Project:	NEWTECH Skill Center Phase 2 Modernization Spokane Public Schools 4141 North Regal Street Spokane, WA 99207	Date:	October 20, 2015
BWA No:	14-370	Addendum No:	Three

This Addendum consists of a total of 5 pages and 10 drawings.

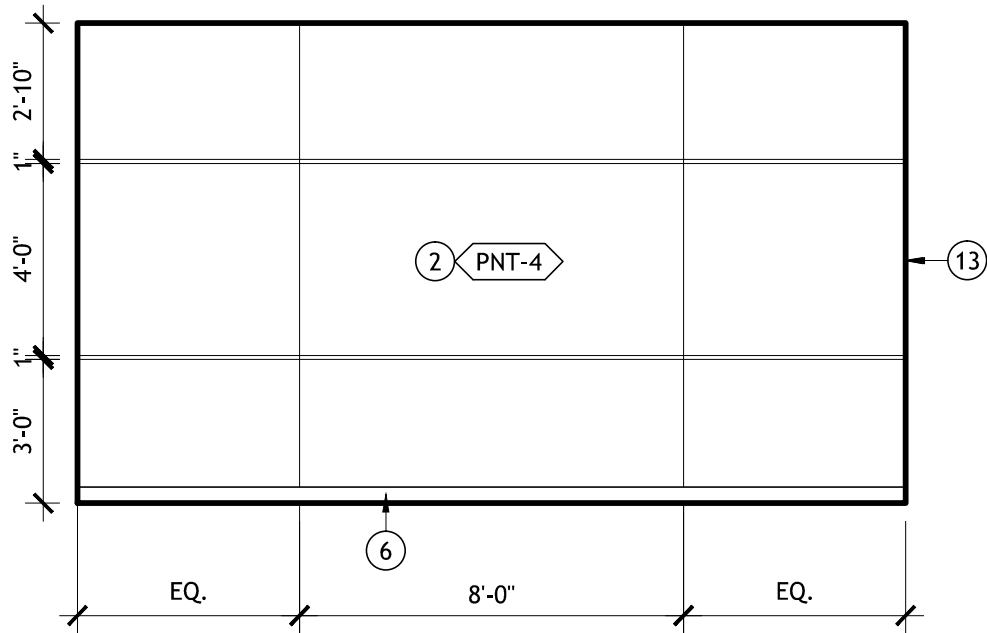
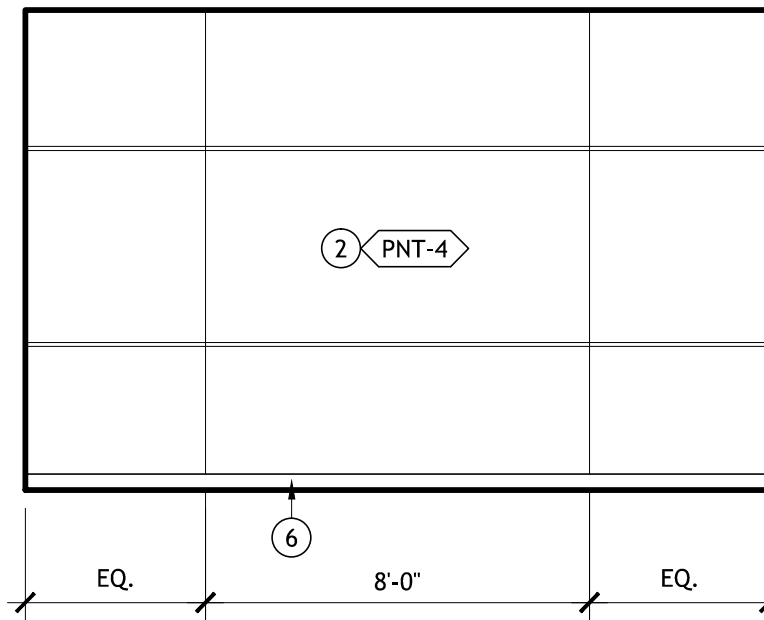
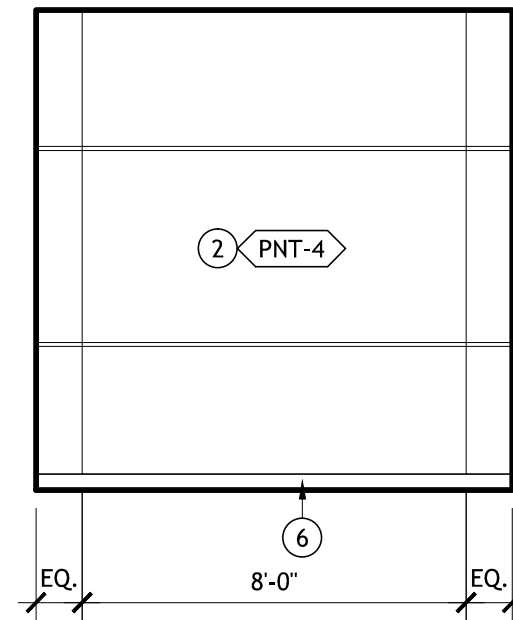
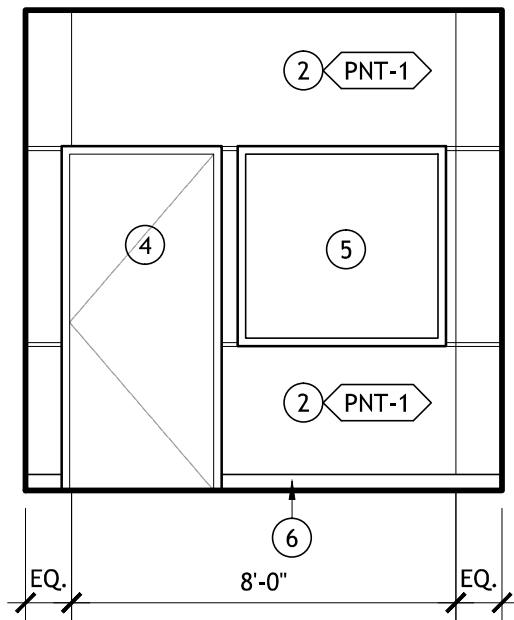
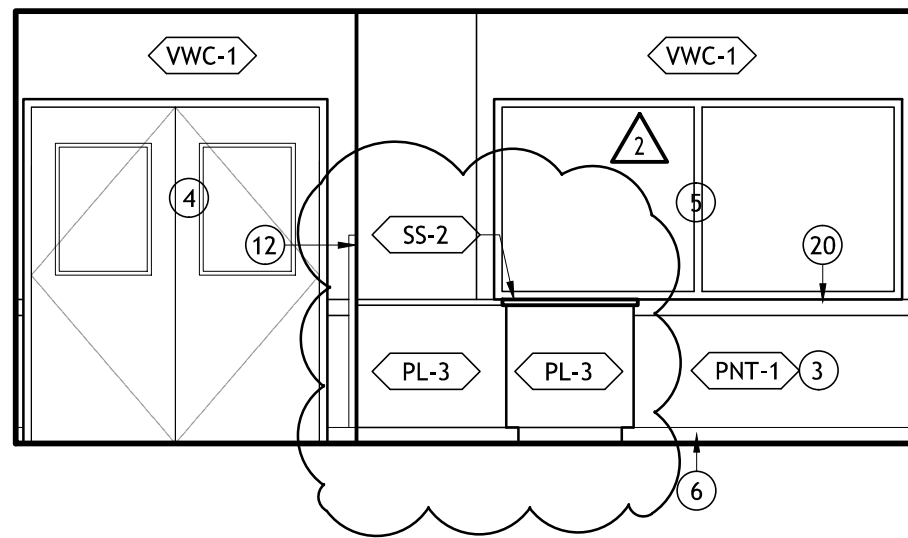
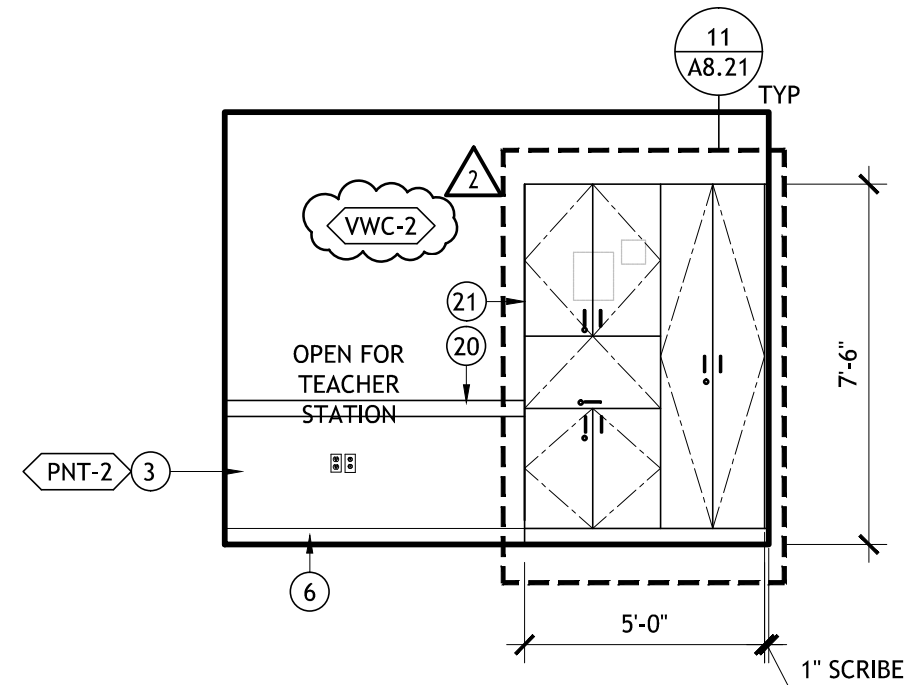
- a. Elevations, Detail 2, 3, 4: Clarification: MDF panels are to be included in base bid.
 - b. Elevations General Notes & Keyed Notes – Add Notes. See attached drawing A3.01

- c. Revise Detail 1-6. See attached drawing A3.02.
 - d. Revise Detail 7-8. See attached drawing A3.03.
 - e. Revise Detail 9-11. See attached drawing A3.04.

STORAGE CABINET RM 107A
RE: SHEET A8.21, DETAIL 17

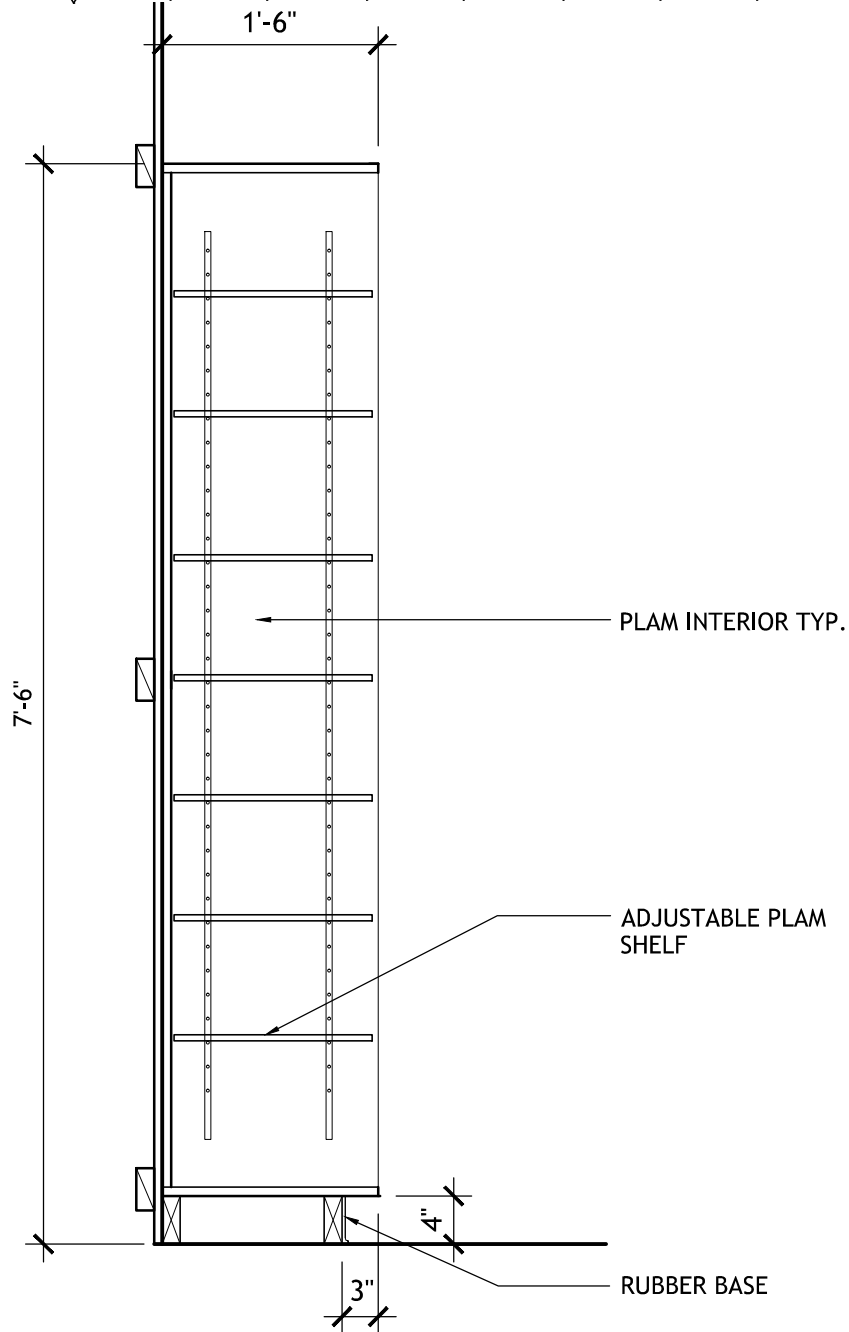
- a. Add Detail 17. See attached drawing A3.05.
6. Sheet M2.14 – Floor Plan – Industrial Manufacturing Training Building – HVAC
 - a. Shift electric duct heater to the north in order to provide the required 36” clearance. This also requires shifting of the mixed air duct to the north and changing to an eccentric transition to the return grille. See attached clarification drawing MC-11.
